City of Delray Beach
NE 2nd Avenue/Seacrest Beautification – Phase 2
Change Order 001

**CITY OF DELRAY BEACH
CHANGE ORDER TO ORIGINAL CONTRACT**

CHANGE ORDER NO. 1 PROJECT NO. 16-032 DATE: September 4, 2018

PROJECT TITLE: NE 2nd Ave. Seacrest Beautification Phase 2

SHEET:
C-10

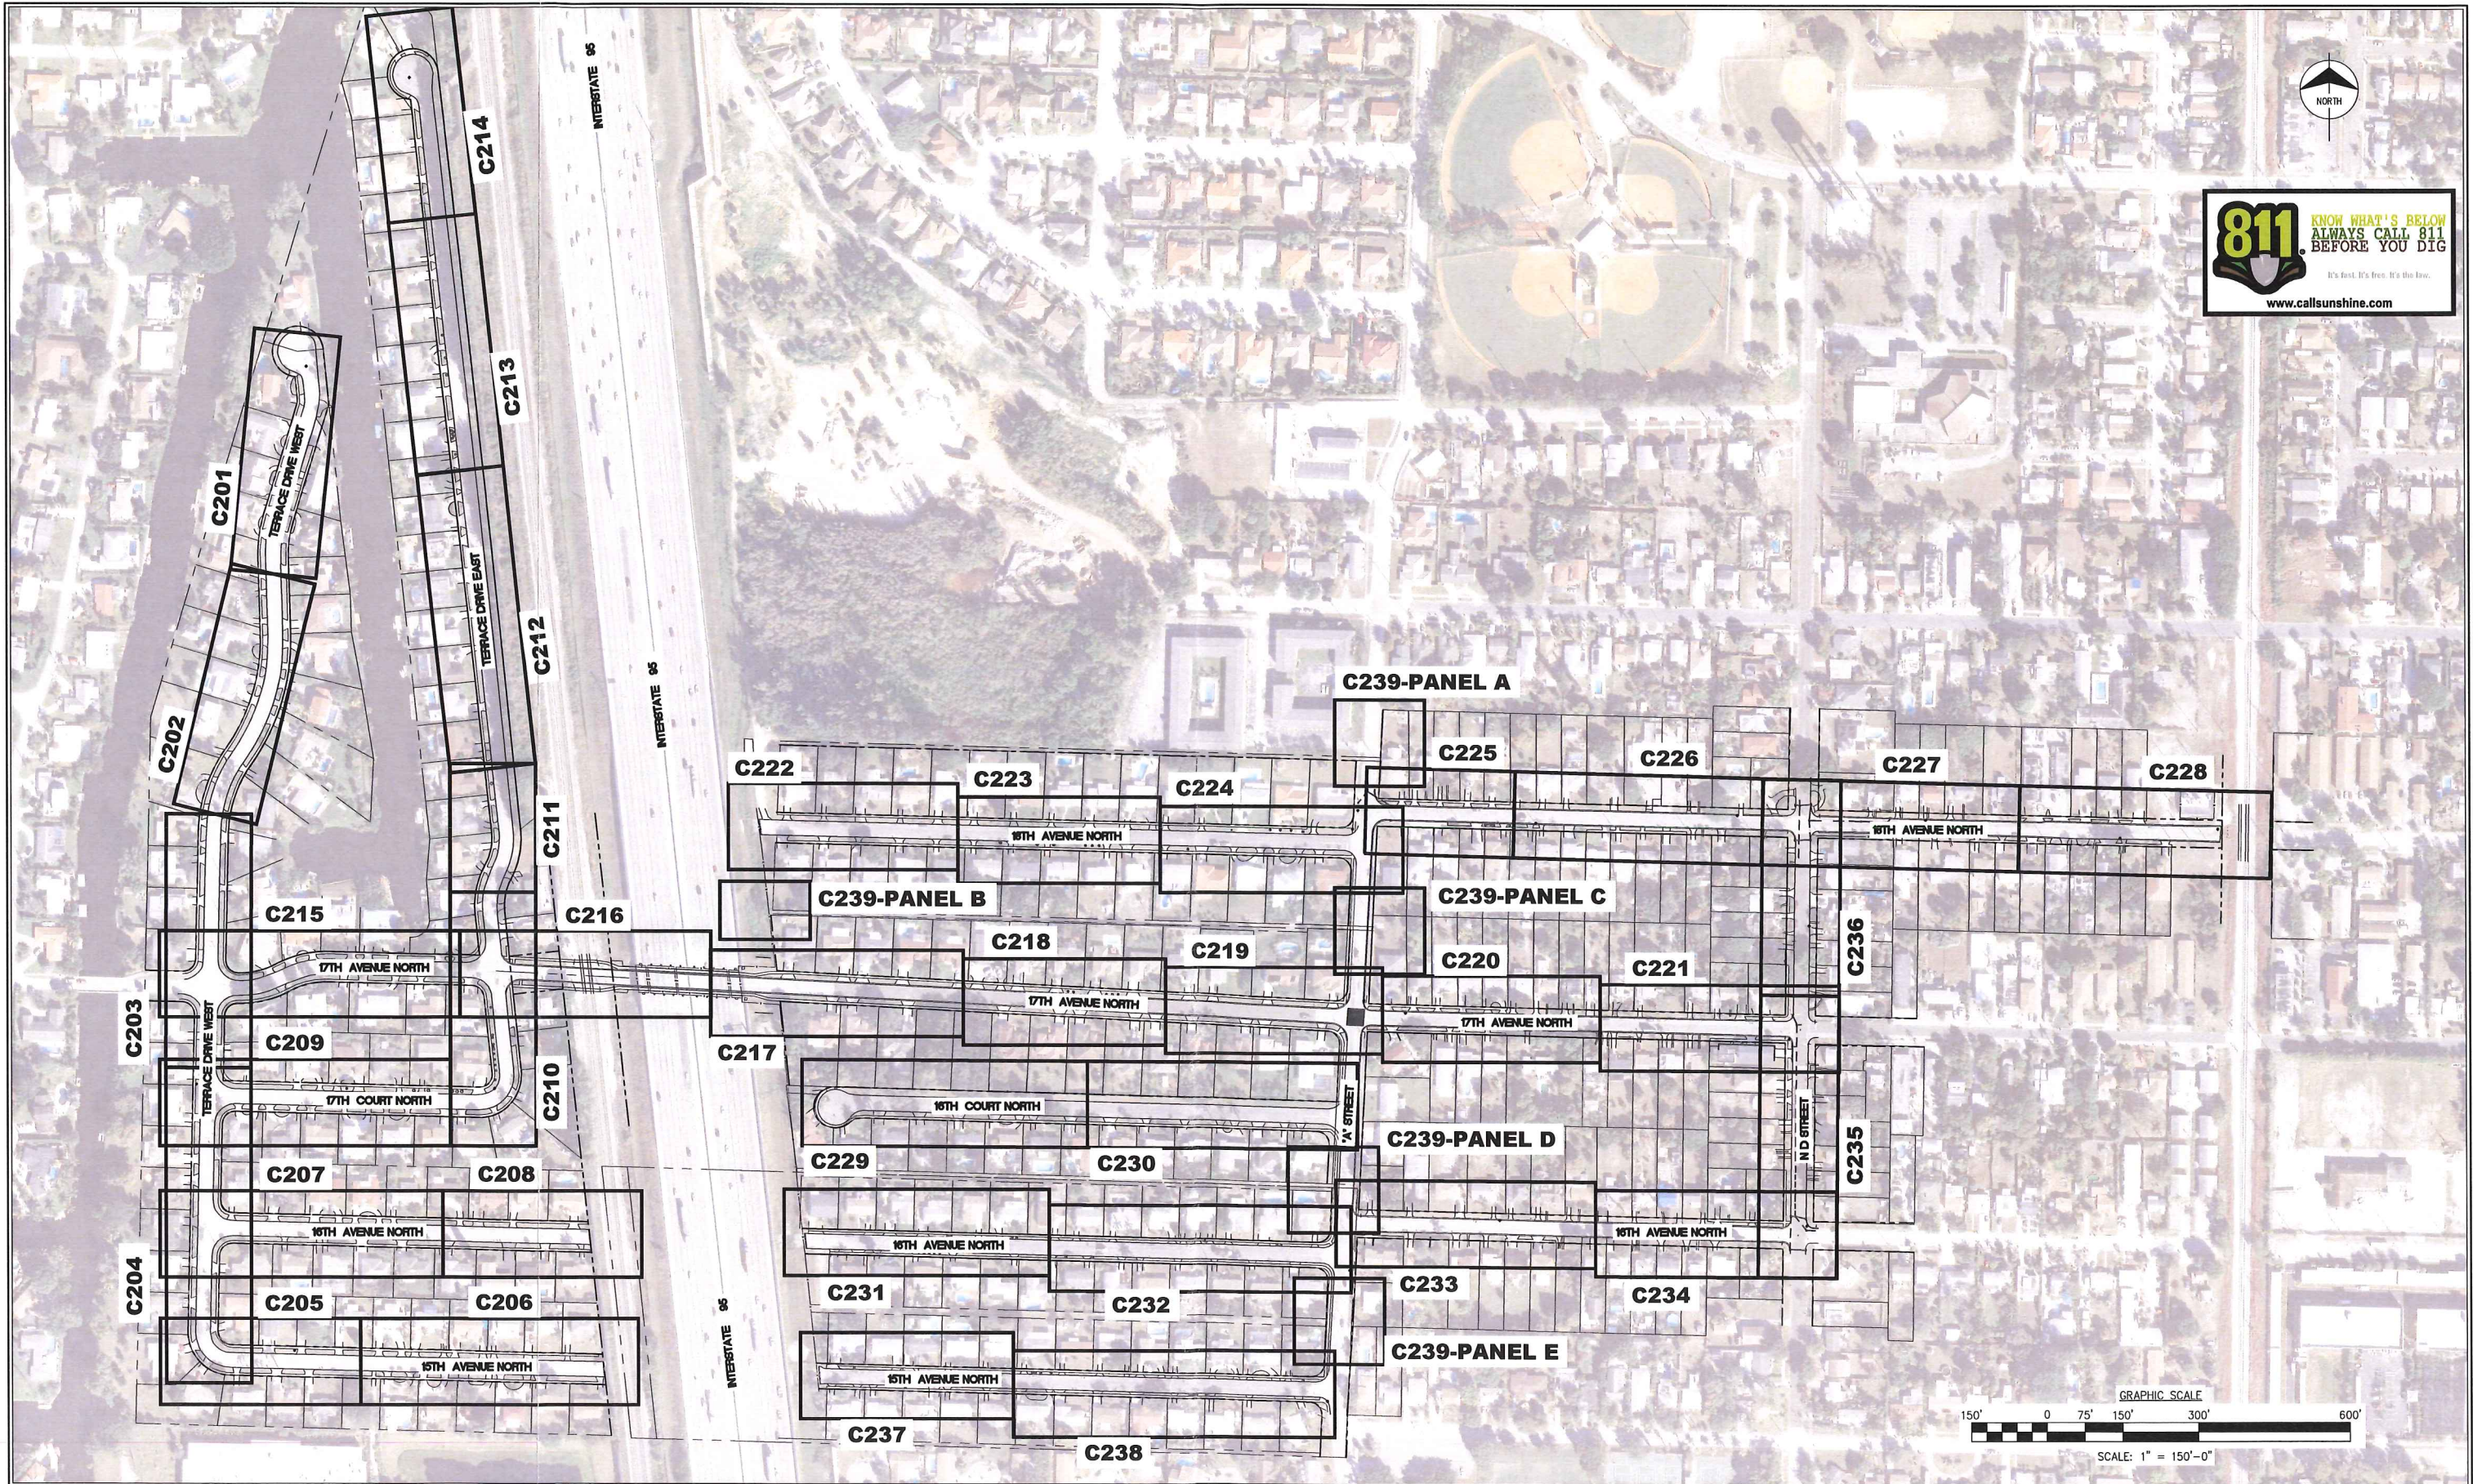
This Change Order also includes a quantity overrun projection for Pay Item #14 Pavement Removal. Our current total projection for this quantity is 2,601.20 square yards. The Bid Quantity Amount for this item is only 1,300 square yards. This results in a quantity overrun of 1,301.20 square yards. The total cost of this Quantity Overrun will result in an increase to the Contract in the amount of \$38,125.16.

Asphalt Removal **4920.6 SQ FT**

Asphalt Driveway... **1589.5 SQ FT**
